Town of Arlington, MA Redevelopment Board

Agenda & Meeting Notice November 7, 2022

3. Public Hearing Docket #3717 80 Broadway

Public Hearing Docket #3722 141 Massachusetts Avenue

A-2.10

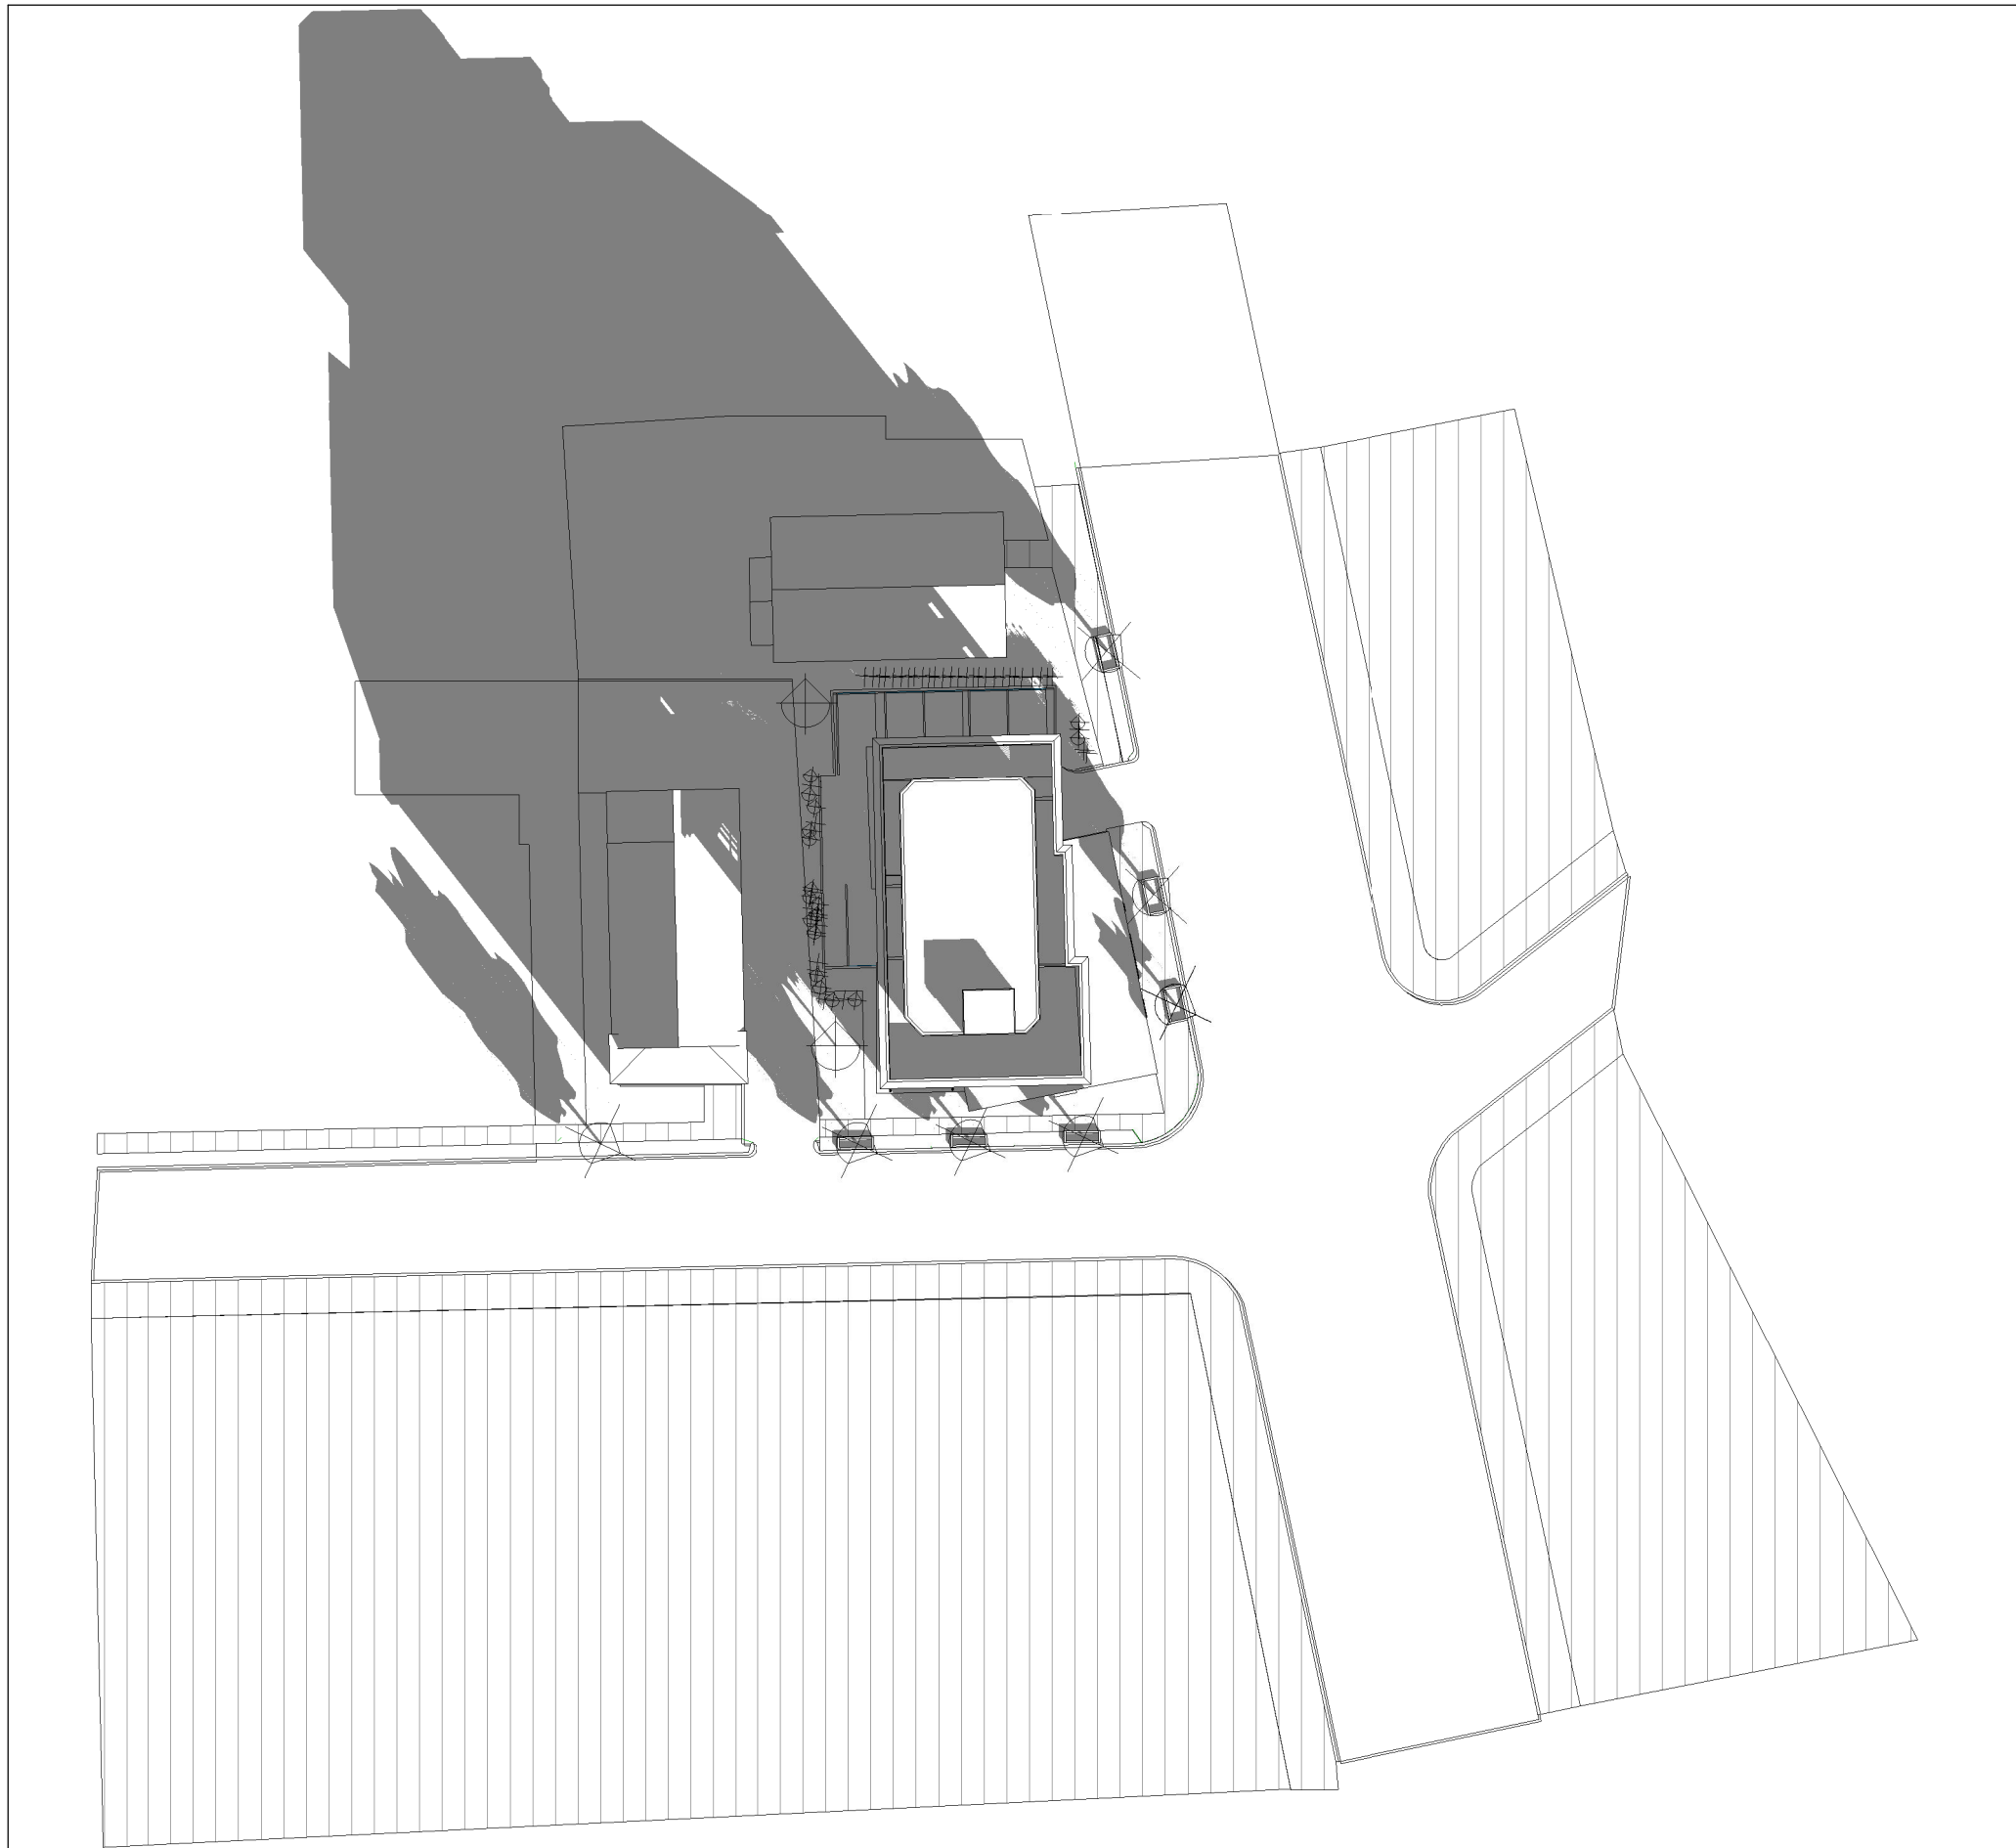
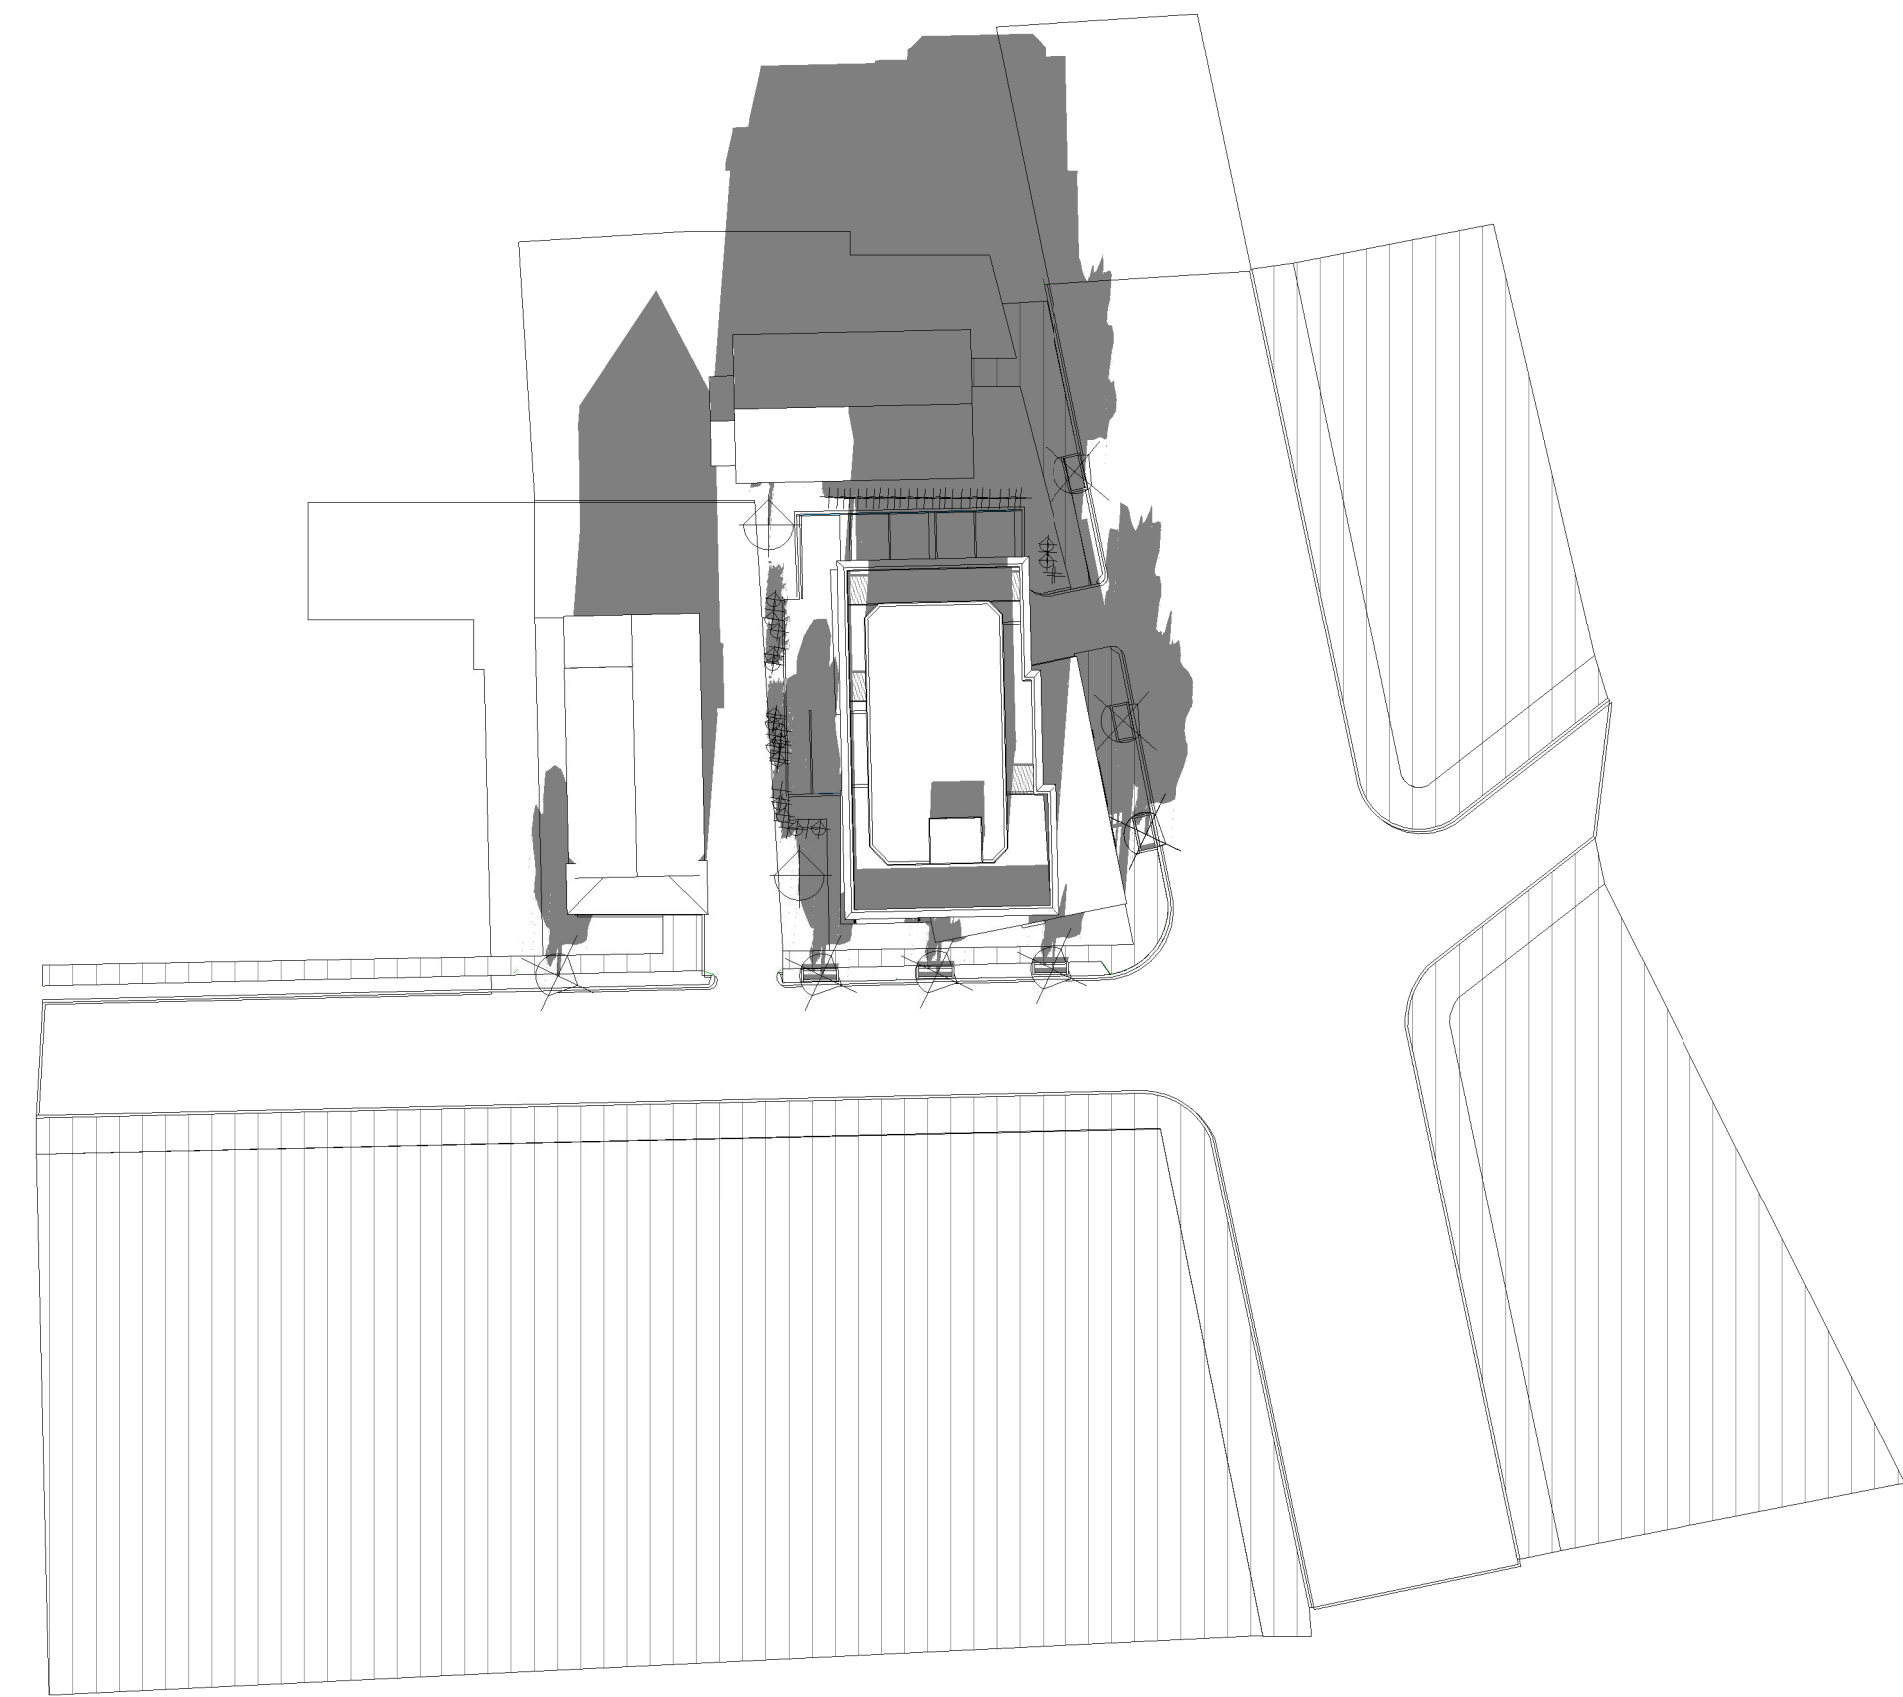
5. Could the applicant provide the Board with corrected and more detailed solar impact drawings A2.10 - A2.13? These drawings incorrectly show Broadway as running North to South, more than 60° off from reality. These drawings omit any detail of the affected properties, notably the array of solar panels on the roof of 88 Broadway.
